THE COUNTY OF GALVESTON

PROJECT NAME: **Galveston County Road & Bridge Facility Rebuild Project**

SOLICITATION NO: **ITB #B201044**

RE: **ADDENDUM #2**

C4.0-PH1
SHEET NUMBER

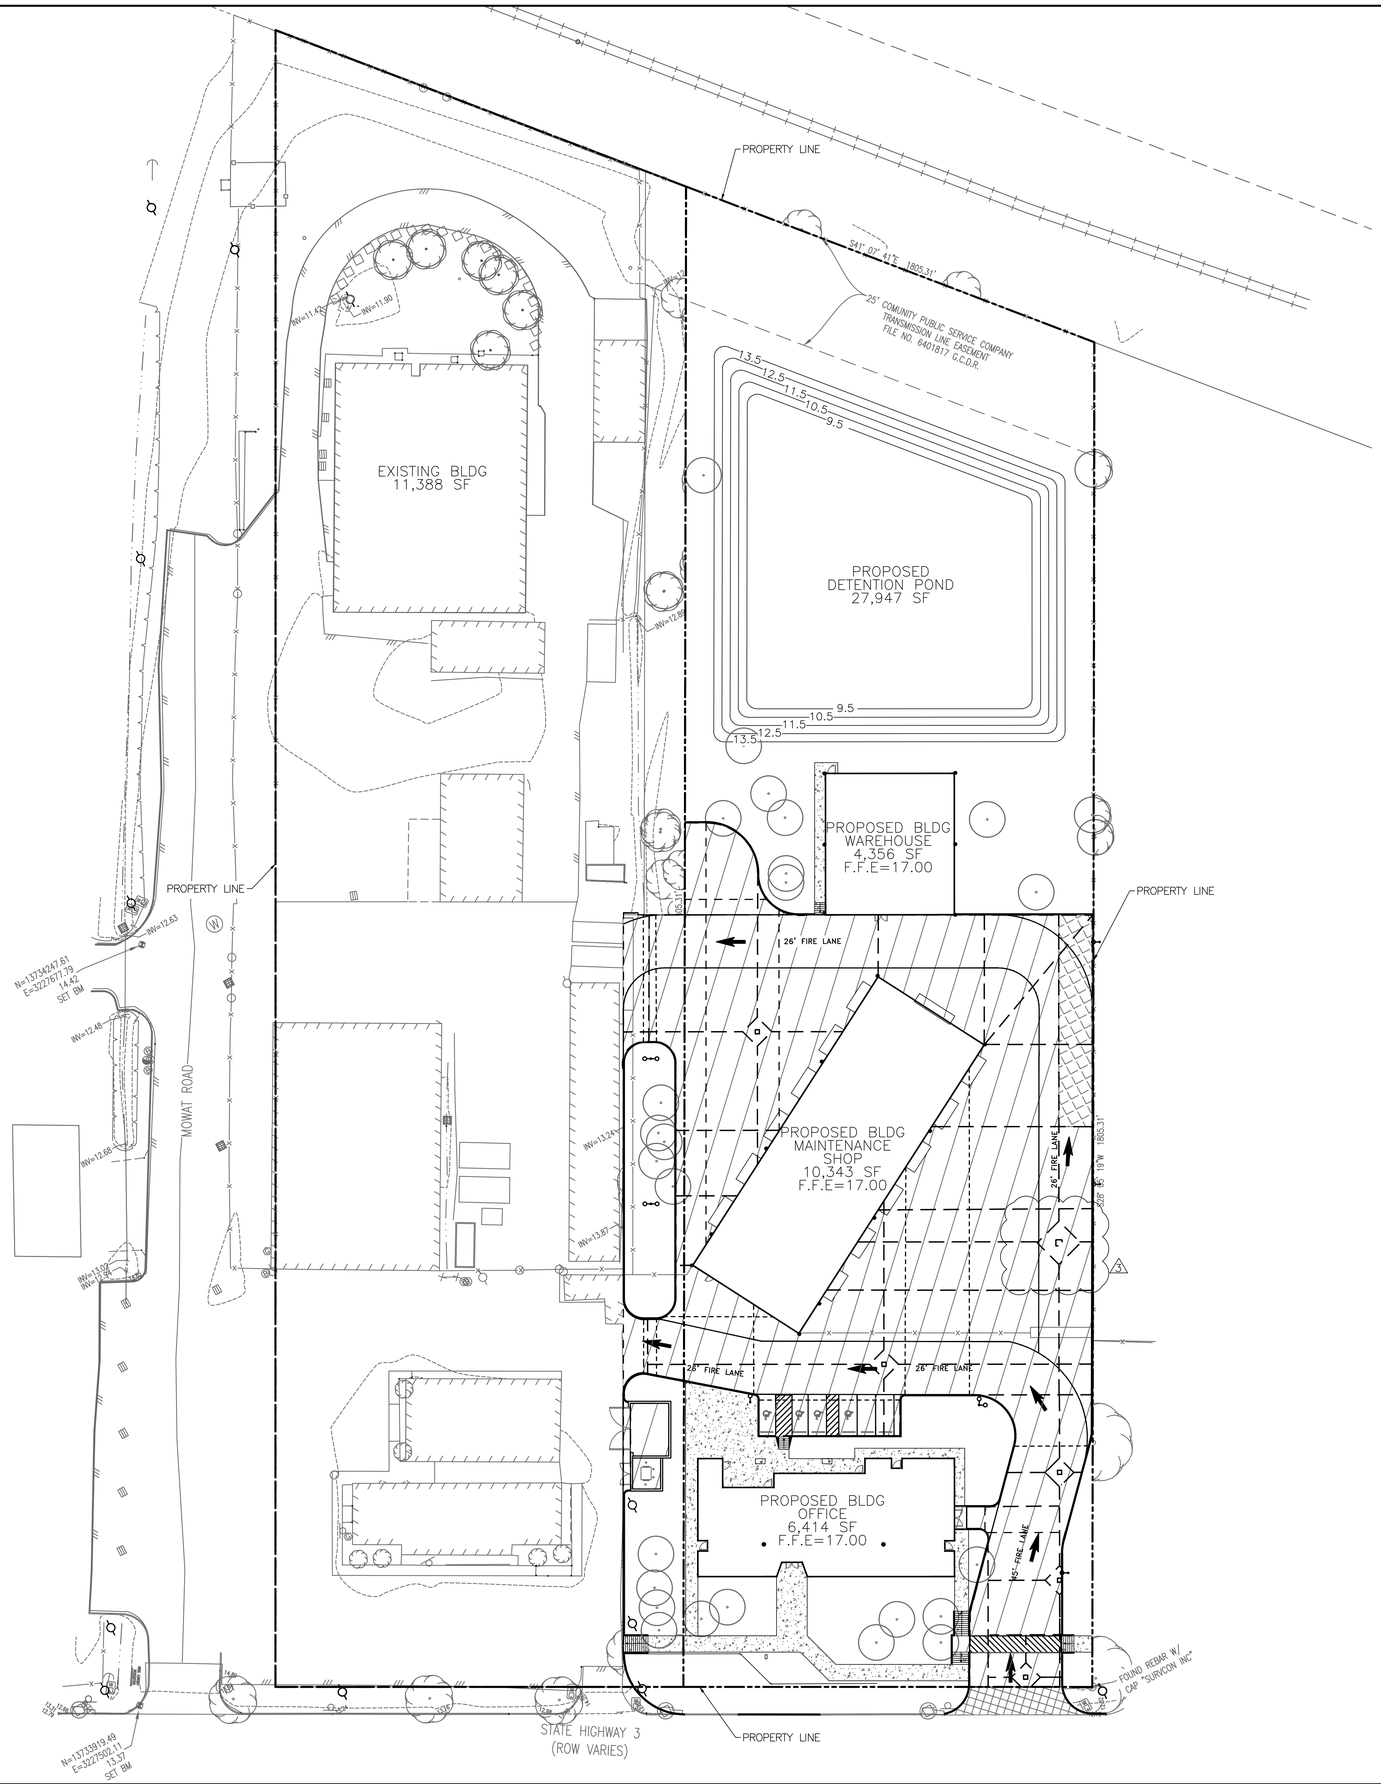
4. C4.0-PH1 – Revised expansion joint layout.
5. C5.0-PH1 – Revised junction box locations.
6. C5.0-PH1 – Revised storm drain inlet location.
7. C6.0-PH1 – Revised junction box elevation.

STORM SEWER PLAN

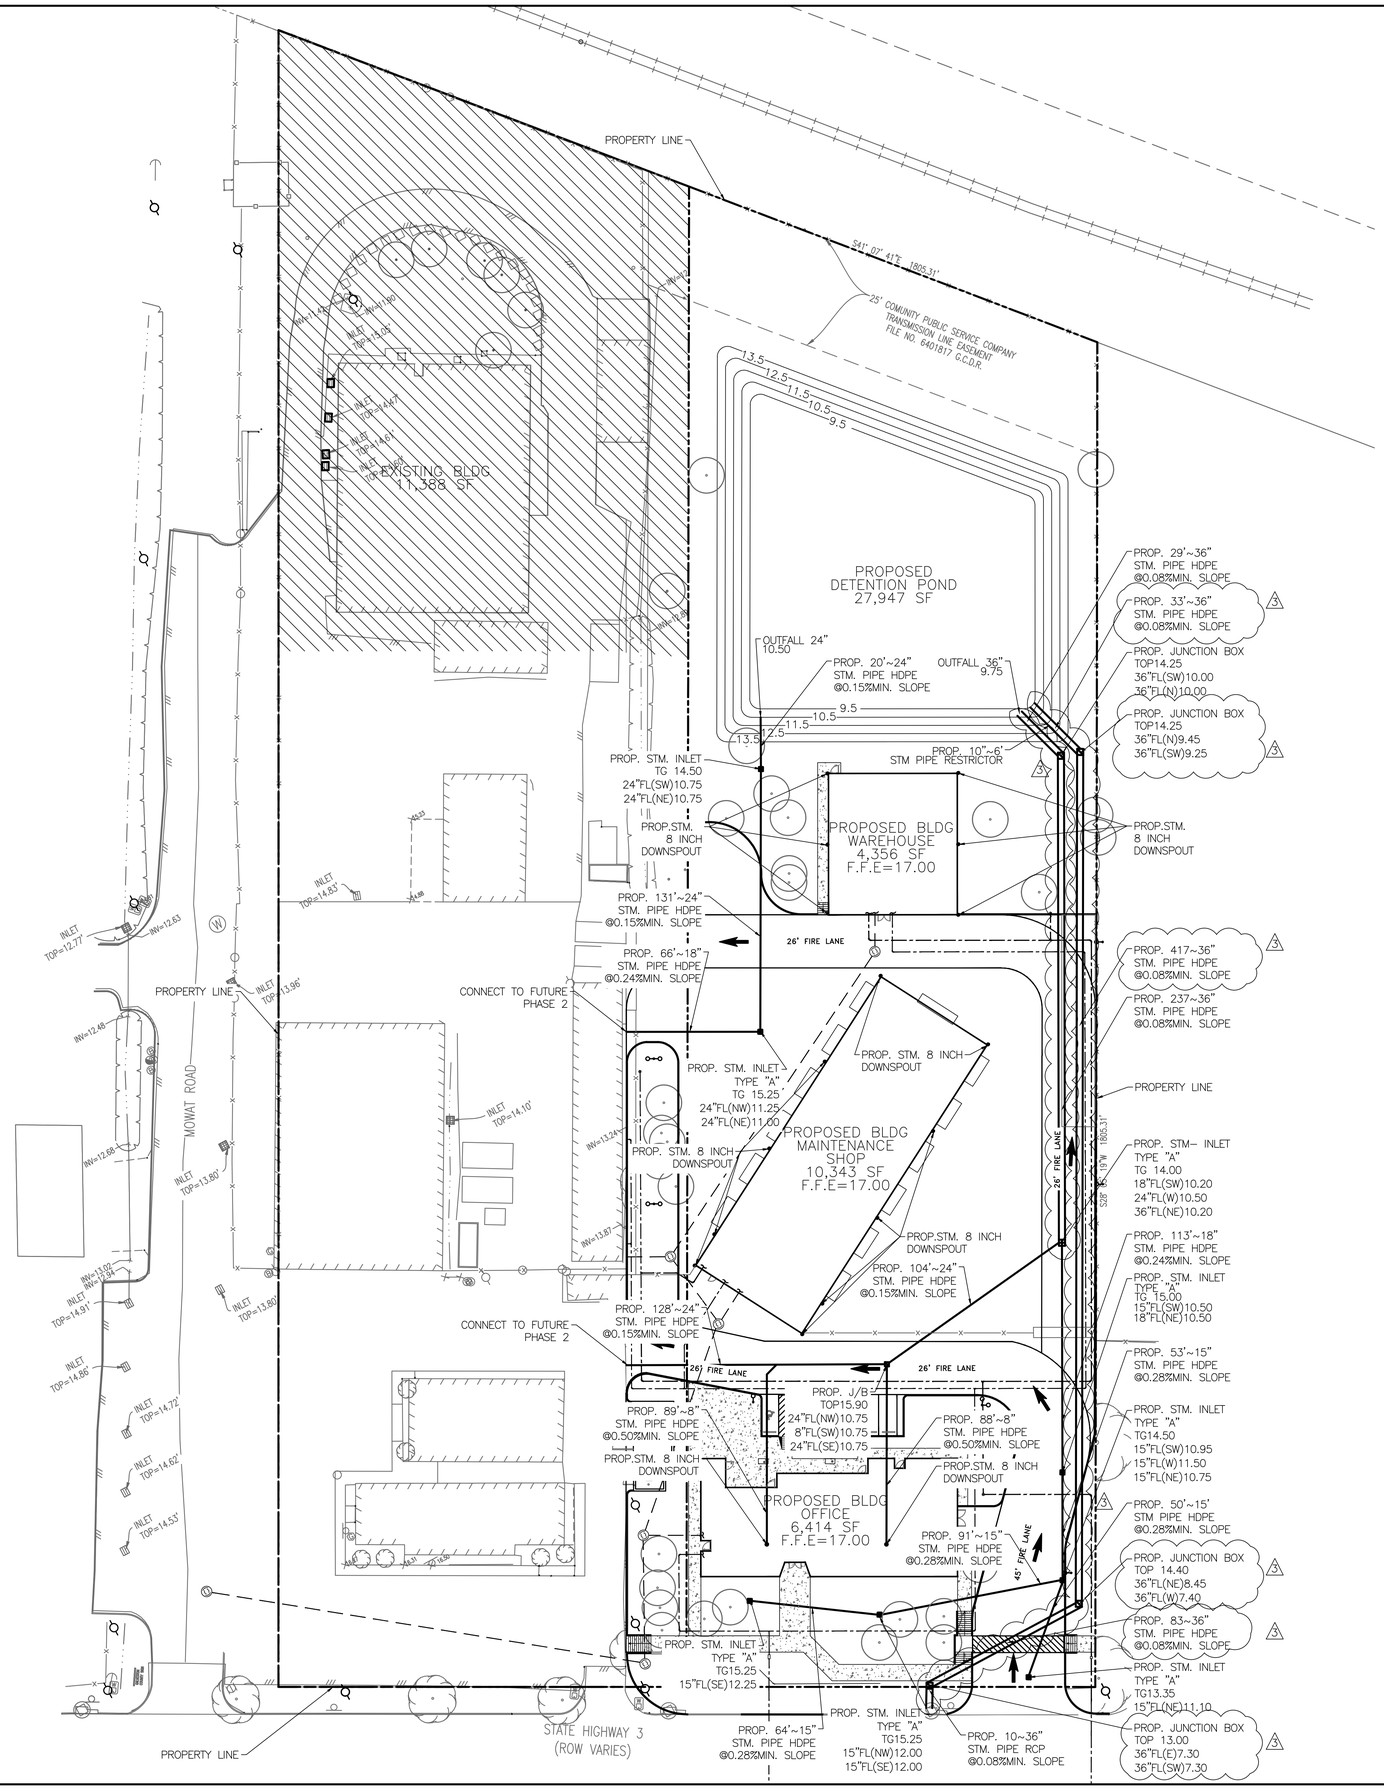
8. C7.0-PH1 – Revised junction box and storm drain inlets.
9. C7.1-PH1 – Revised sanitary sewer manholes.
10. C10.0-PH1 – Added “ParkUSA Type-A Grate Inlet” detail No. CB4880-1

C5.0-PH2
SHEET NUMBER

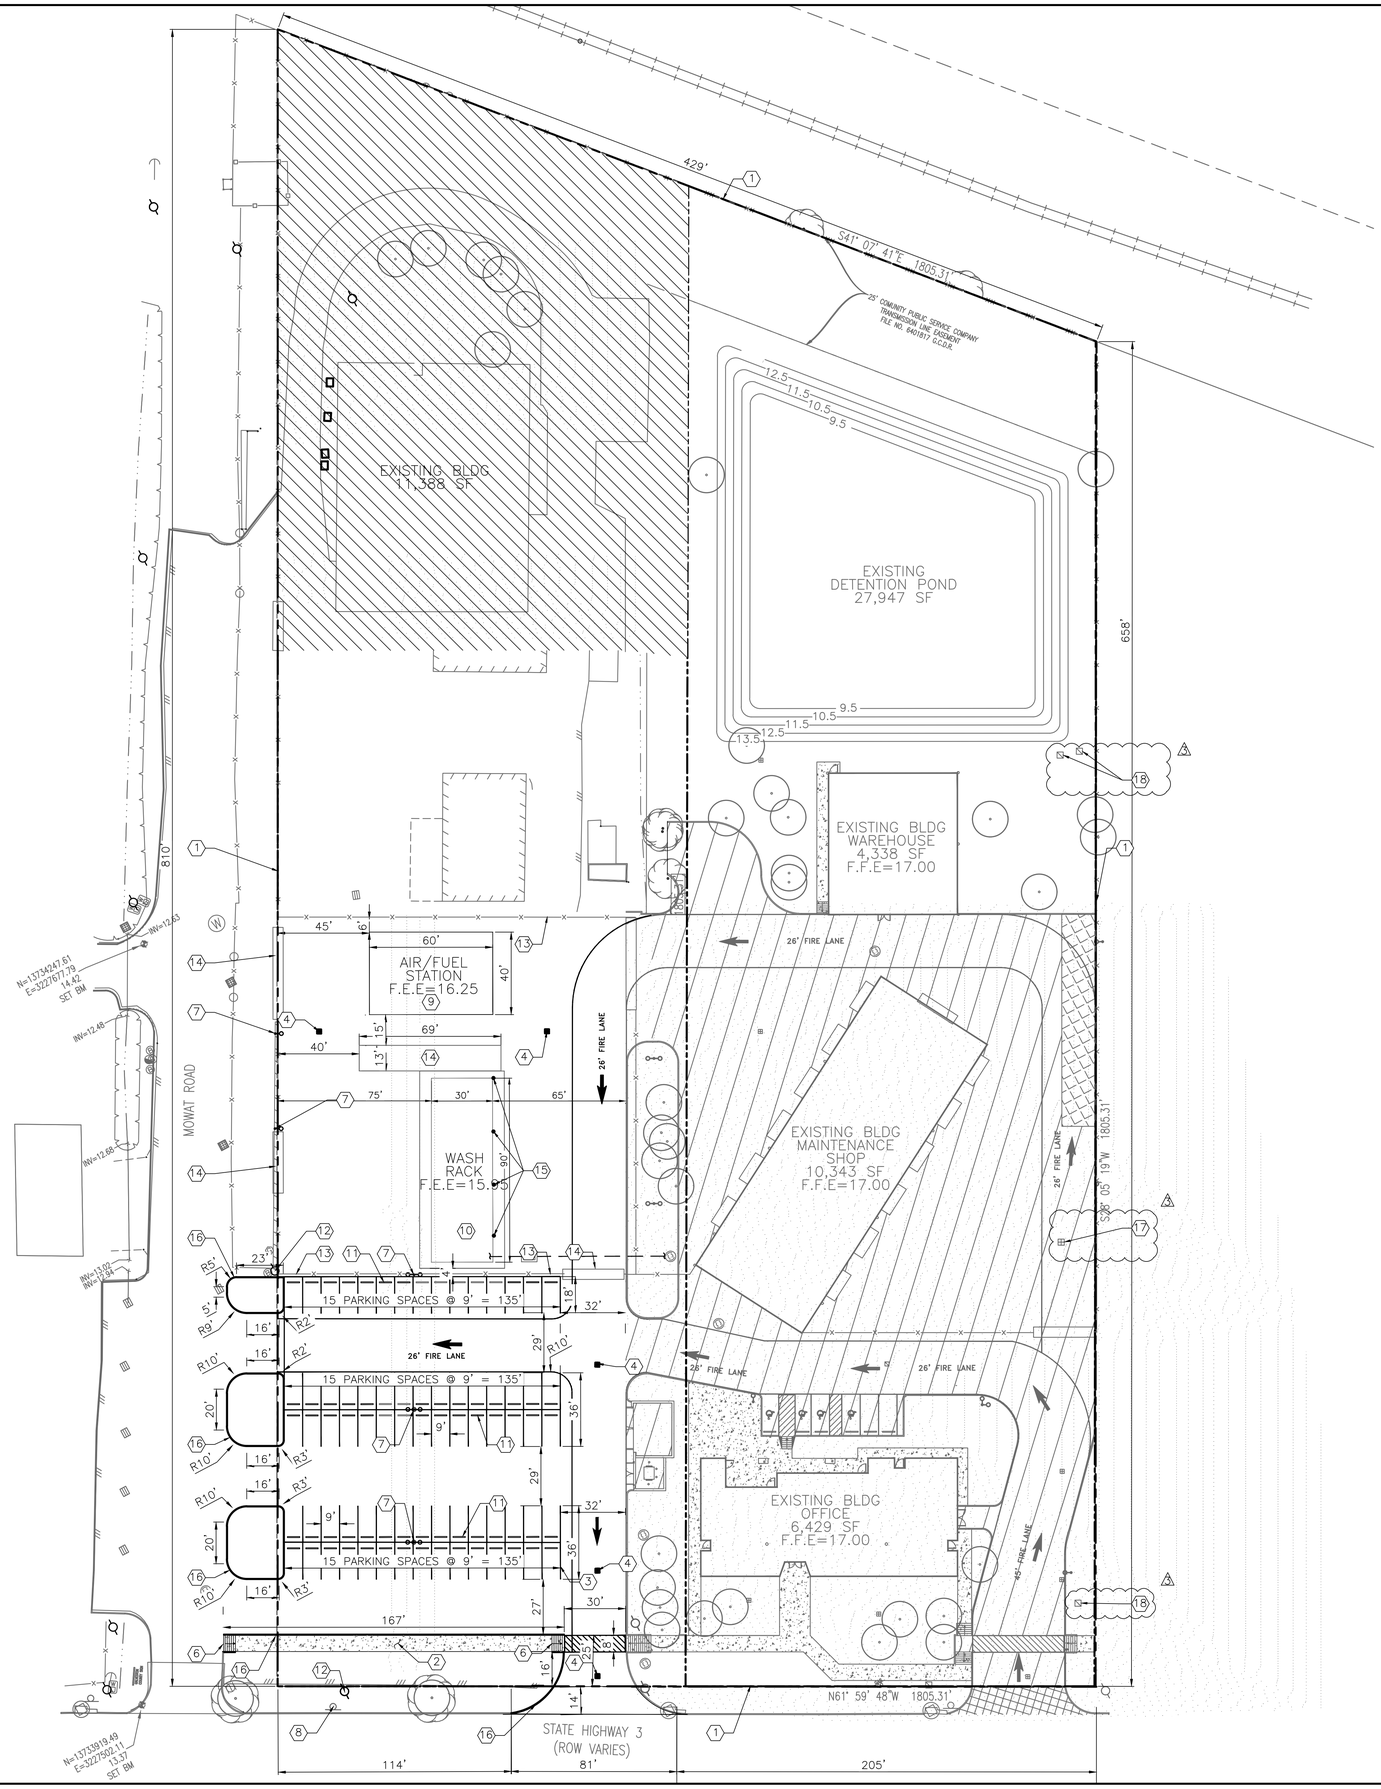
11. C13.0-PH1 – Revised inlet protection barrier.
12. C13.0-PH1 – Added inlet protection barrier callout.
13. C5.0-PH2 – Revised phase of junction boxes and inlets.

SANITARY SEWER PLAN

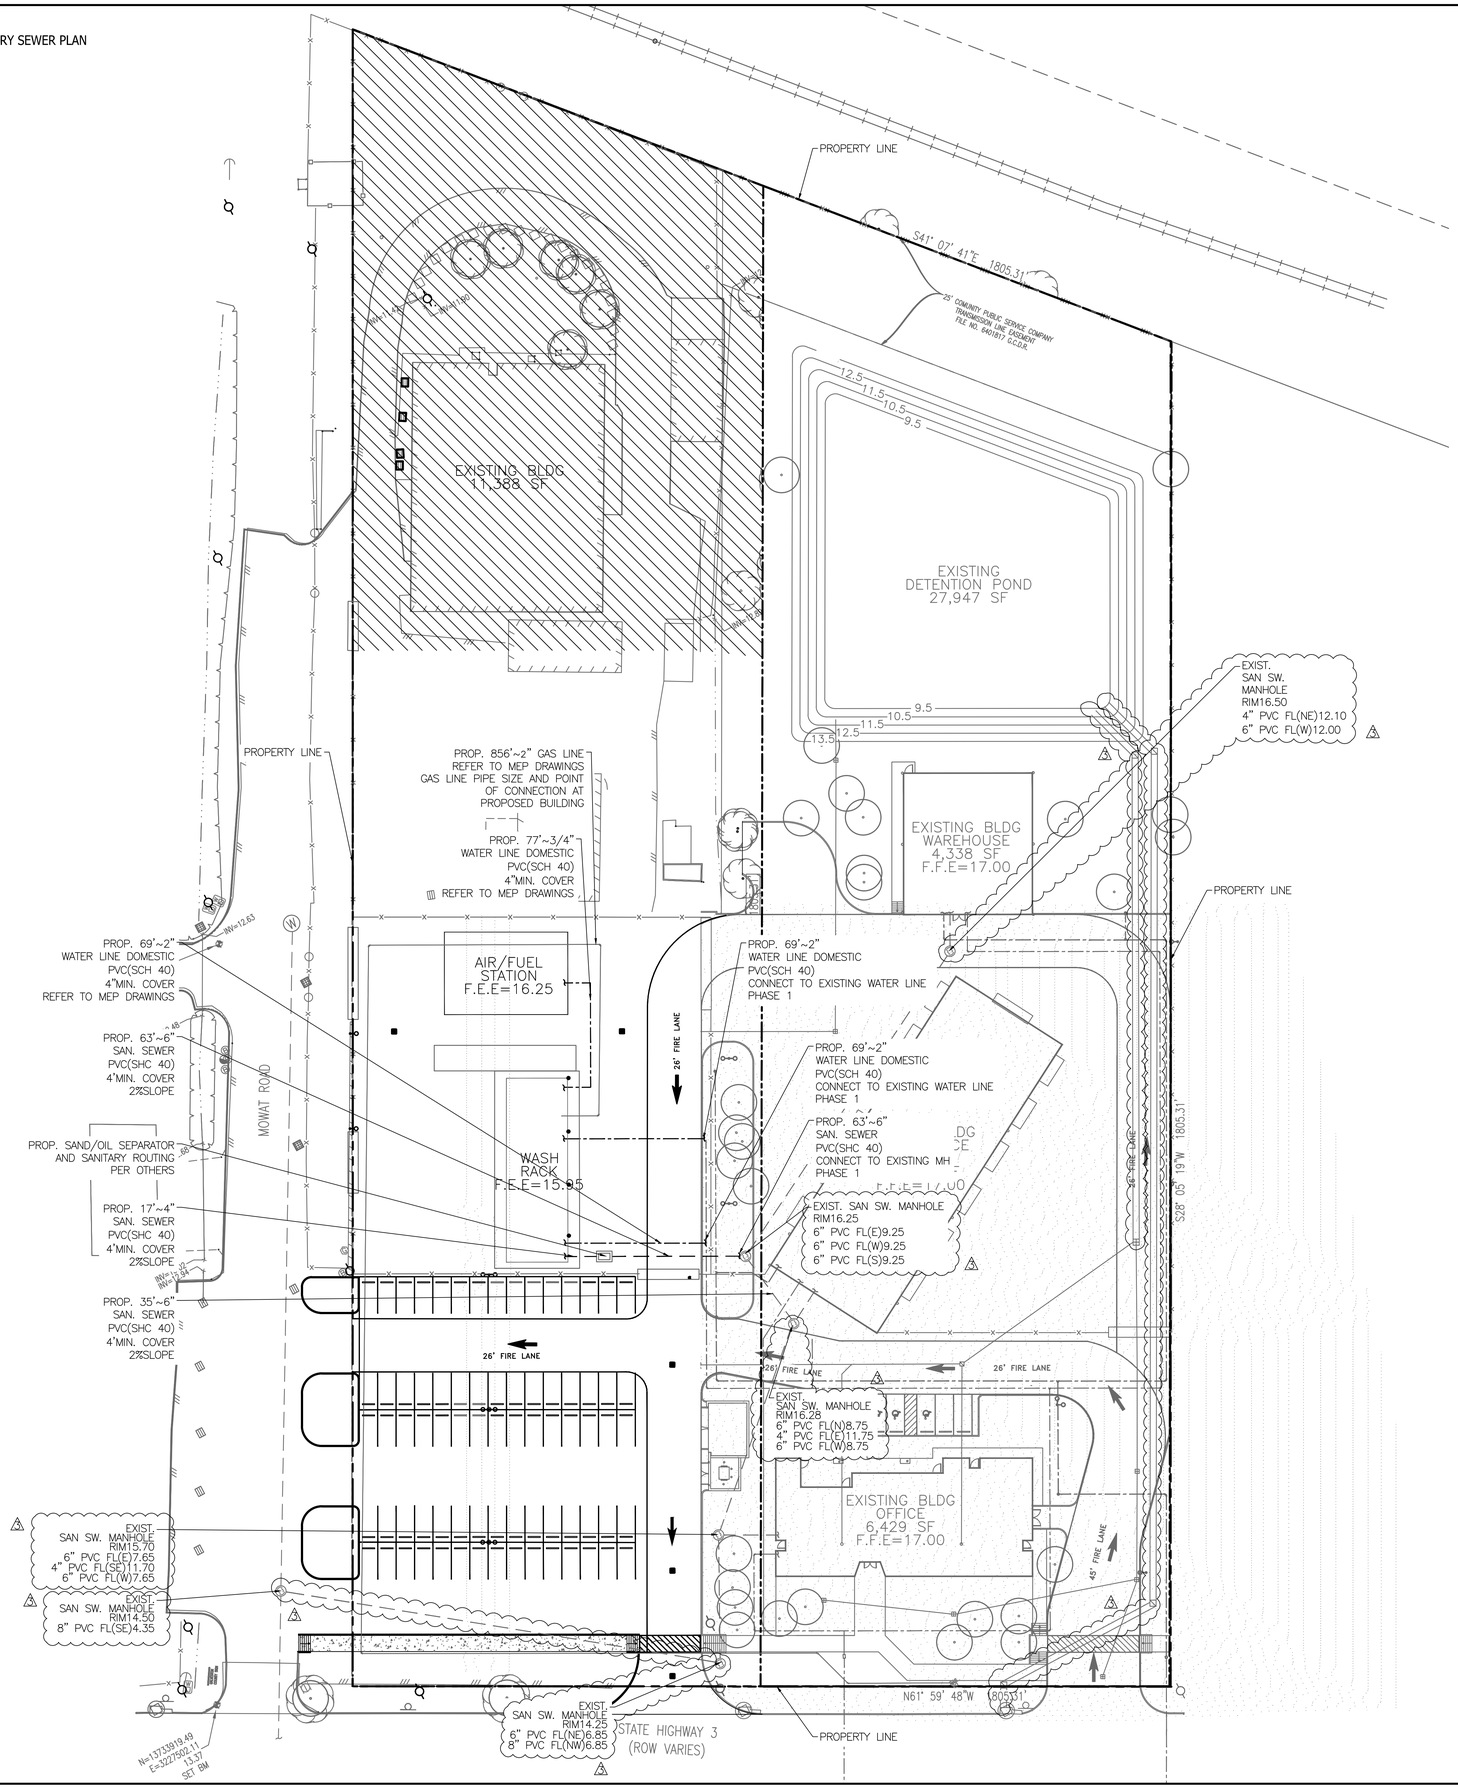
14. C7.1-PH2 – Revised phase of sanitary sewer manholes.
15. A-201O – Revised brick masonry finish tags; Added Masonry Legend.
16. A-110M – Revised dimensions at Restroom M5.
